SWIM PROJECT PROFILE		File No. : 194
Regist. No. : Agency No. : BSWM-113	Name: LABOON SWIP	
Region: 8	Province: SOUTHERN LEYTE	Municipality: MAASIN
Present Status: 1. Pre-F/S( )    ② F/S(1983)    ③ D/D(1983)		
Purpose: Major : Irrigation Incidental : IF, FC, WM		
Project Feature:

SWIM PROJECT PROFILE		File No. : 195
Regist. No. : Agency No. : BSWM-114	Name: POLANQUI SWIP	
Region: 8	Province: EASTERN SAMAR	Municipality: TAFT
Present Status: 1. Pre-F/S( ) ② F/S(1983) ③ D/D(1983)		
Purposo: Major : Irrigation Incidental : IF, FC, WM		
Project Feature:

SWIM PROJECT, PROFILE		File No. : 209
Regist.No. : Agency No. : BSWM-129	Name: DUMALAGAN SWIP	
Region: 10	Province: AGUSAN DEL NORTE	Municipality: BUTUAN CITY
Present Status: 1. Pre-F/S( ) (2) F/S(1983) (3) D/D(1983)		
Purpose: Major : Irrigation Incidental : IF, FC, WM		
Project Feature:

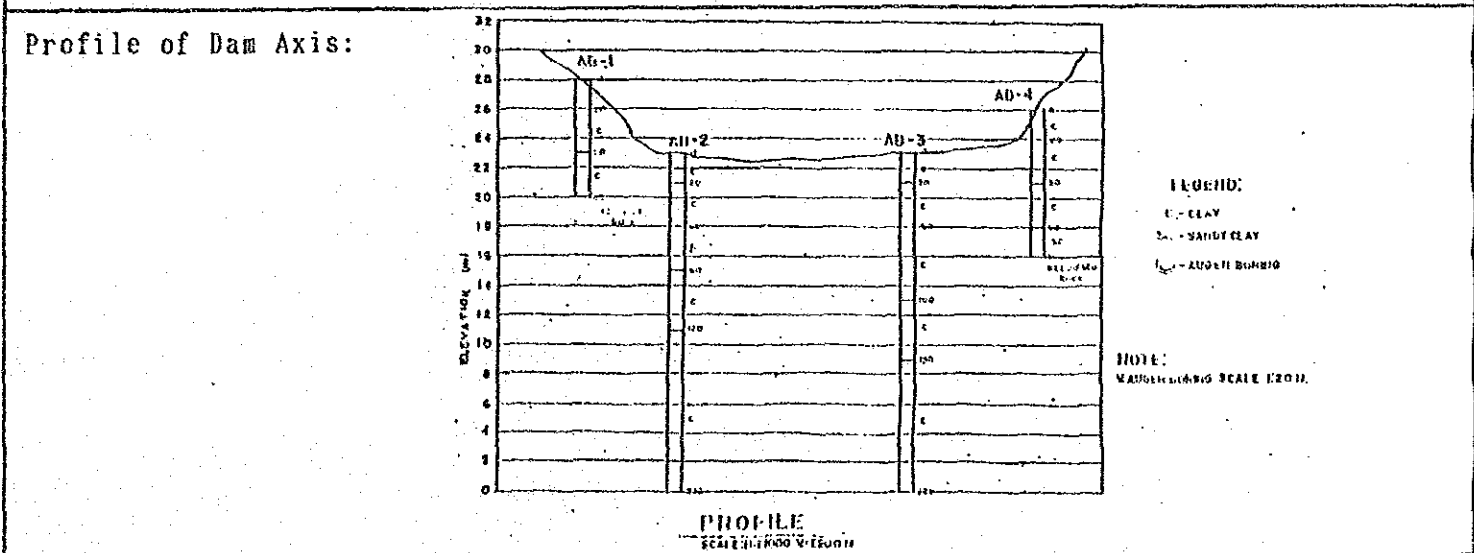
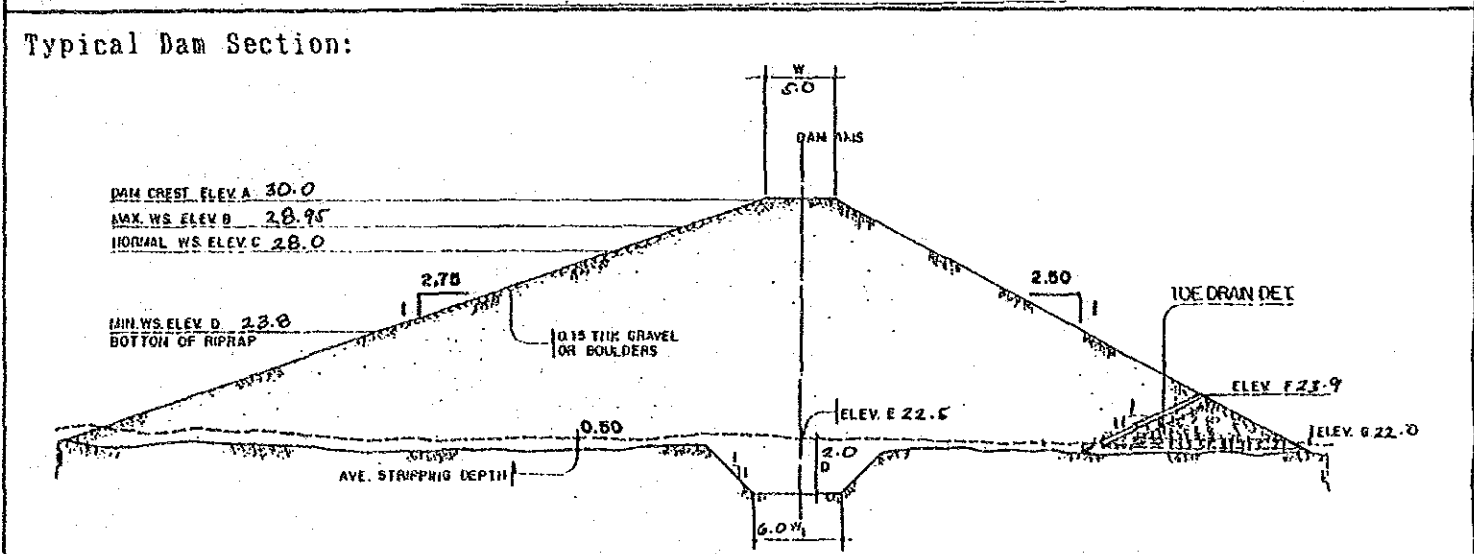
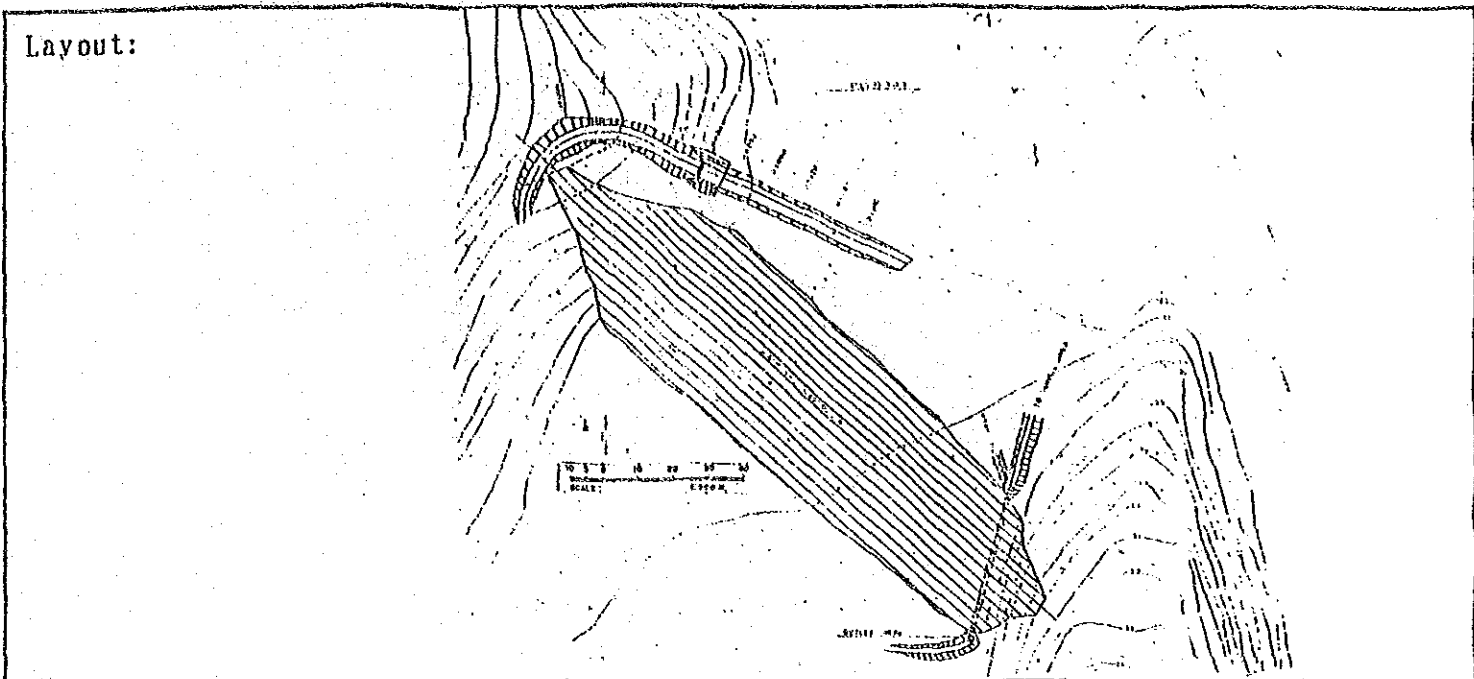
6. Inland Fishery	Annual Production :	13 ton/year
Technical Assessment:		
1. Survey and Investigation: Depth of test pit or auger boring is not enough. Bearing capacity and permeability are not measured. Available volume for dam embankment shall be studied before construction.

2. Planning Environmental conservation plan is not formulated.		
3. Design Depth of core trench shall be modified during construction. Stability of upstream slope of the dam shall be checked. Weir shall be provided in the spillway.

SWIM PROJECT PROFILE		File No. : 210
Regist.No. : Agency No. : BSWM-130	Name: MINTU-OD SWIP	
Region: 10	Province: AGUSAN DEL NORTE	Municipality: BUENAVISTA
Present Status: 1. Pre-F/S( )    ② F/S(1983)    ③ D/D(1983)		
Purpose: Major : Irrigation Incidental : IF, FC, WM		
Project Feature:

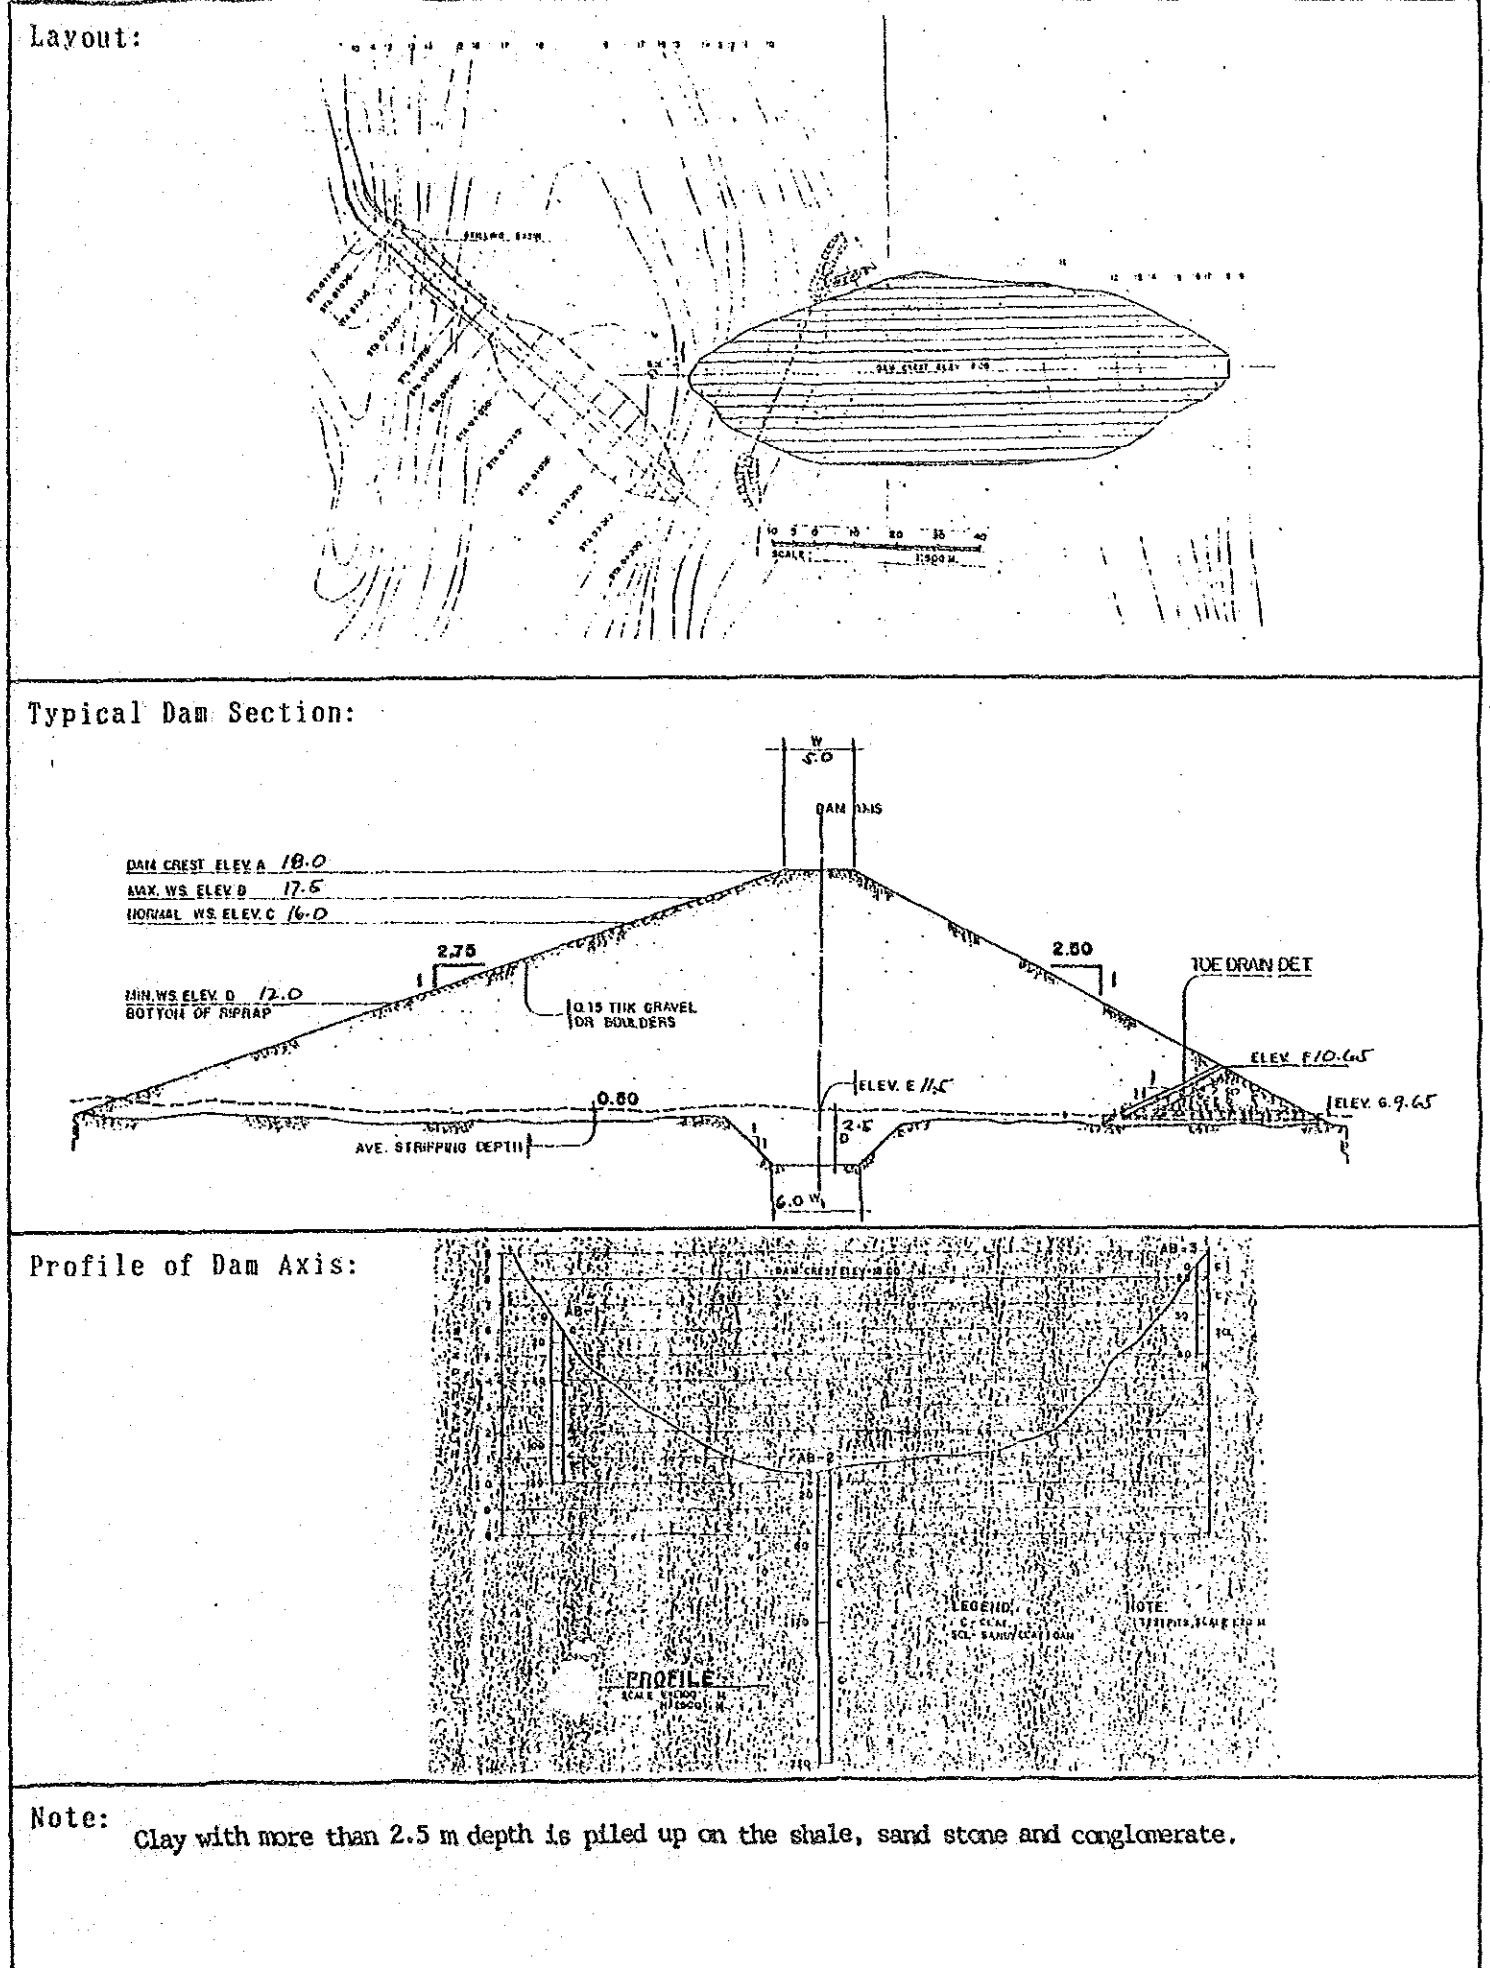
2. Planning Environmental conservation plan is not formulated.		
3. Design Depth of core trench shall be modified during construction. Stability of upstream slope of the dam shall be checked. Freeboard is not enough. Weir shall be provided in the spillway.

SWIM PROJECT, PROFILE		File No. : 211
Regist. No. : Agency No. : BSWM-131	Name : MALAPONG SWIP	
Region: 10	Province: AGUSAN DEL NORTE	Municipality: BUENAVISTA
Present Status: 1. Pre-F/S( ) (2) F/S(1983) (3) D/D(1983)		
Purpose: Major : Irrigation Incidental : IF, FC, WM		
Project Feature:

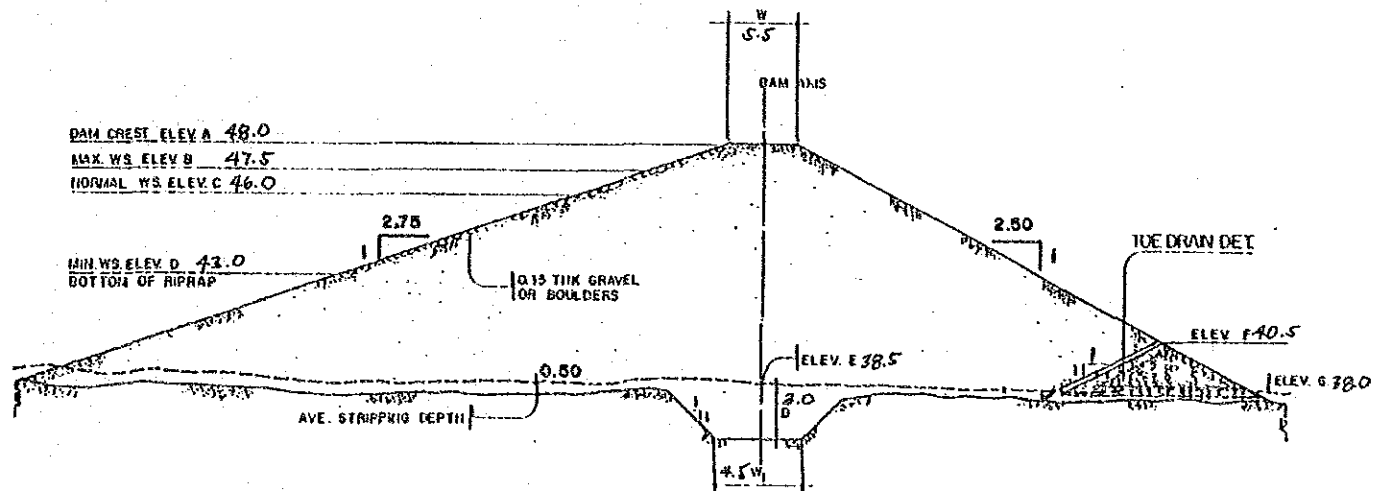
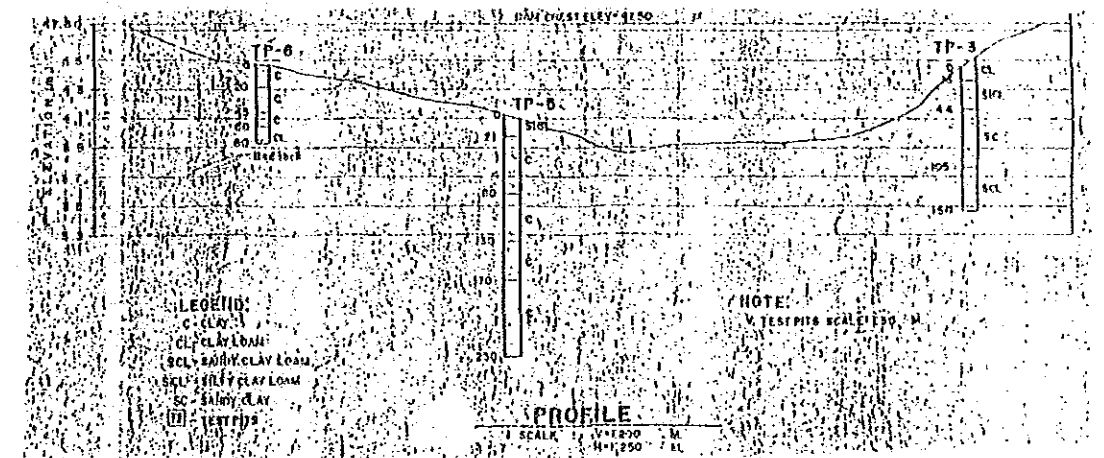
2. Planning Environmental conservation plan is not formulated.		
3. Design Depth of core trench shall be modified during construction. Stability of upstream slope of the dam shall be checked. Center line of the spillway shall be shifted to left side. Weir shall be provided in the spillway.

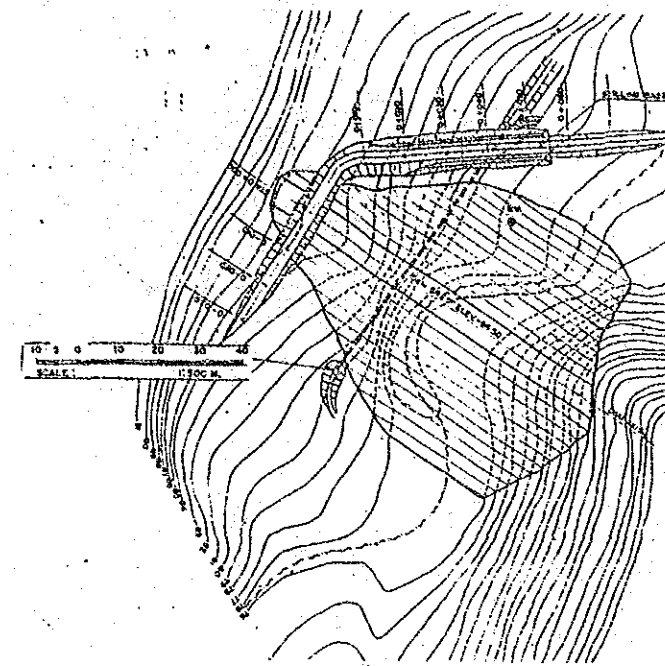
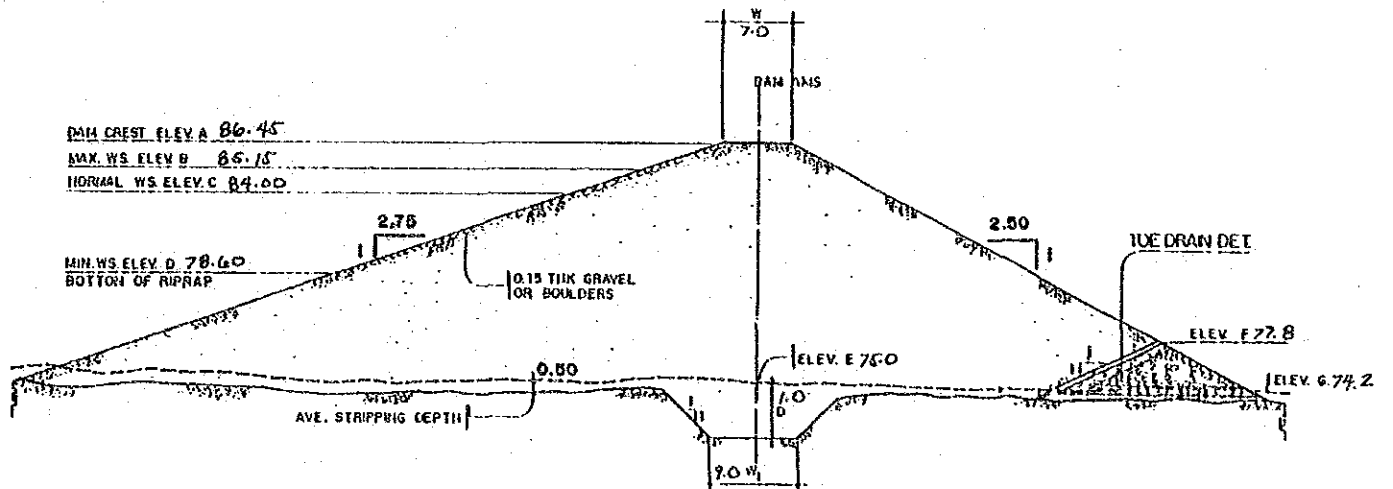
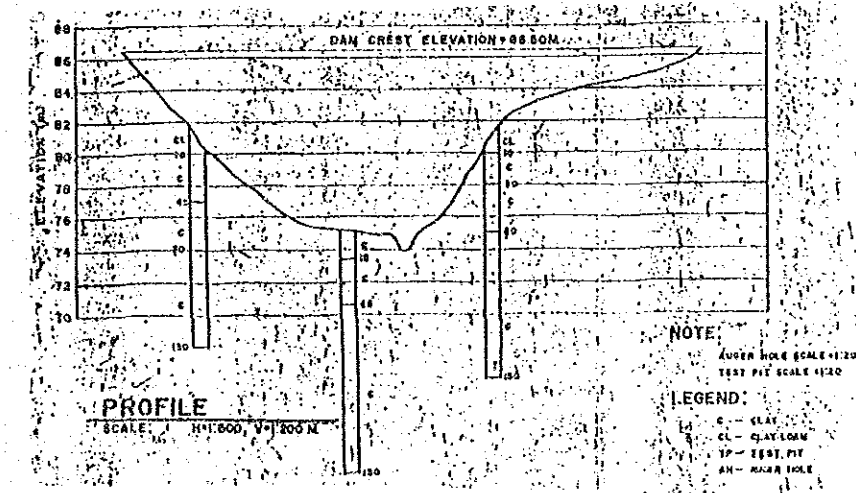
2. Planning		
Environmental conservation plan is not formulated.		
3. Design		
Depth of core trench shall be modified during construction.		
Stability of upstream slope of the dam shall be checked.		
Compaction near the spillway shall be carefully carried out.		
Weir shall be provided in the spillway.
